Thank you for your email of 7 December 2021 with accompanying cover letter and Her Honour Coroner Magistrate Audrey Jamieson's Finding (the report) dated 6 December 2021, reference **COR 2018 004310**, without inquest into the death of Mrs Ingeburg Muller on 28 August 2018.

Marquis Street/High Street, Ashburton
Threshold Treatment
Existing Conditions Stage Road Safety Audit

Prepared for: City of Boroondara
Project Ref: TS-22-RSA-5715A
Date: 14 February

Figure 8.8: Indicative dimensions of a wombat crossing

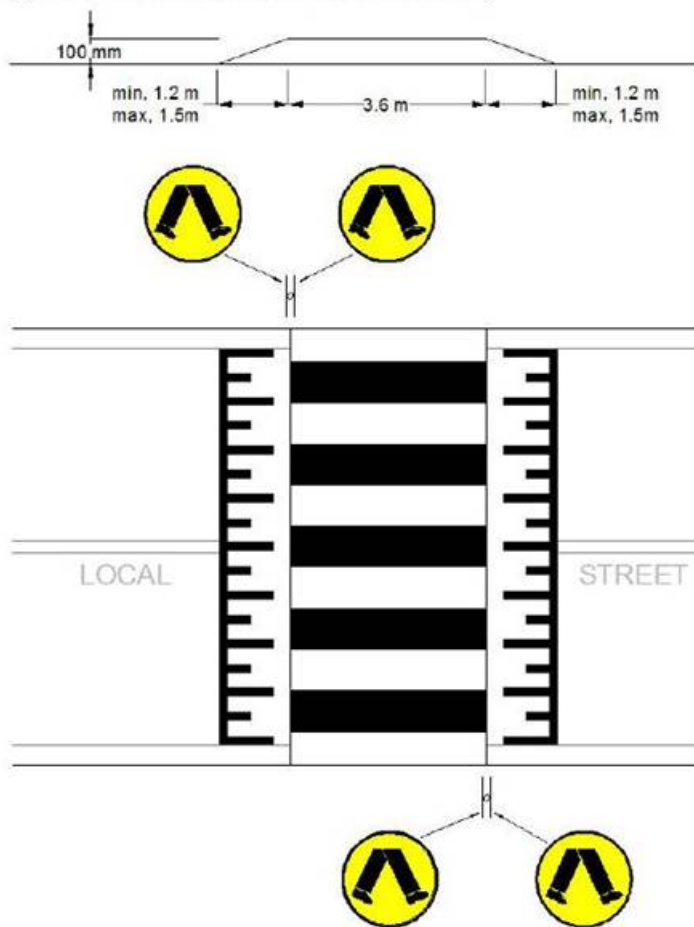
AGTM discusses vertical deflection devices including Wombat Crossings and Flat-Top Humps in Section 8.2, as well as Threshold Treatments and Continuous Footpath Treatments in Section 8.5. Our Road Design and Safe System team recommends leveraging off of the below figure for the recommended height of the device, as well as min. & max. grades for the approach ramps (note that the wombat crossings would not be necessary for a raised pedestrian platform / raised threshold treatment unless there is an intent to provide priority for footpath users over vehicular traffic).

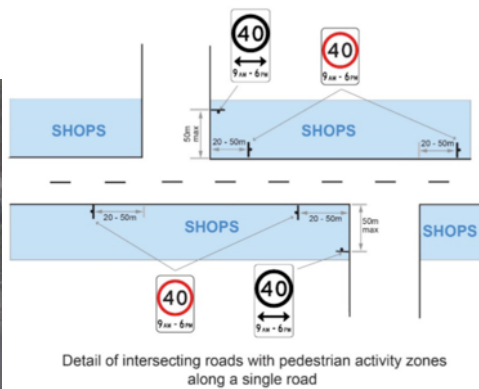
Item	Finding and Commentary / Recommendation	Ranking	Project Team/Client Response	
			Accept Yes/No	Reasons/Comments
10.11	<p>Recommendation (no 58)</p> <p><i>“With the aim of promoting public health and safety and preventing like deaths, I recommend that Boroondara City Council replace the existing advisory speed limit sign of 40 kilometres per hour between the hours of 7.00am to 7.00pm along the northbound lane of Marquis Street to a warning sign of ‘Raised Intersection’ with advisory speed limit of 40 kilometres per hour.”</i></p> <p>Response – The 40km/h advisory speed limit sign on Marquis Street is consistent with DoT guidelines (TEM Vol 3 Part 211 Speed Zoning Guidelines Dec 2021) for signing of activity centres speed zones (i.e. the 40km/h speed limit on High Street). As such the current advisory 40km/h 7am – 7pm should remain.</p>	NA
